SERVICE BULLETIN AMATEUR RADIO

SUBJECT	DATE
TS-950S/SD 80 METER SPURIOUS EMISSION	02/06/91

Some TS-950SD owners have reported a transmit spurious emission between 3.500MHz and 3.520MHz. This modification will reduce the spurious emission to -65dB.

FIGURE 1

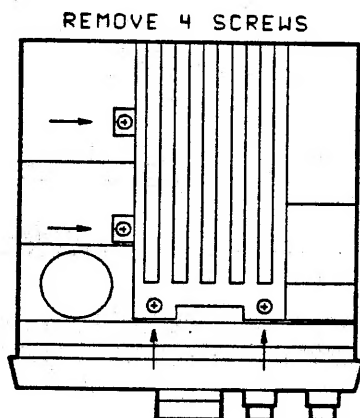
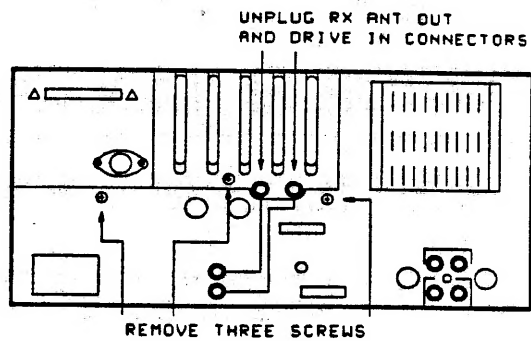
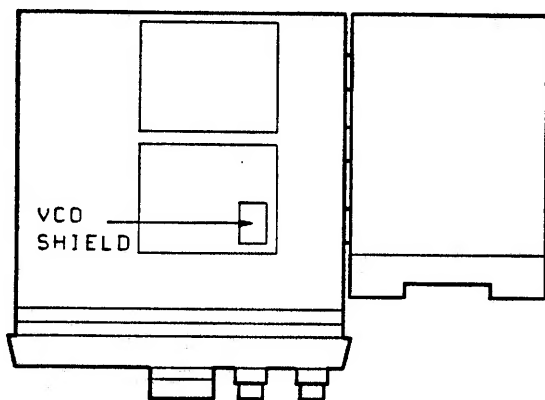
1. Disconnect the power cord and antenna.
2. Remove the top and bottom covers (18 screws).
3. Open the subchassis to expose the PLL board (Figures 1-3). To open the subchassis remove 4 top screws, remove 3 back panel screws, and unplug the RX ANT OUT and DRIVE IN connectors.
4. Replace the four VCO shield plate screws with the type listed above. Figure 3
5. Close the subchassis and secure it with the screws removed in step 3.
6. Locate the A.F. board on the bottom of the transceiver. Figure 4
7. Remove the board's mounting screws and disconnect the necessary connectors to expose the bottom of the board.
8. Locate the foil pattern area shown in Figure 5. This area is below IC11.
9. Cut the foil pattern and add the components shown in Figure 6.
10. Assemble the transceiver. Remember to plug in the two connectors on the back panel.
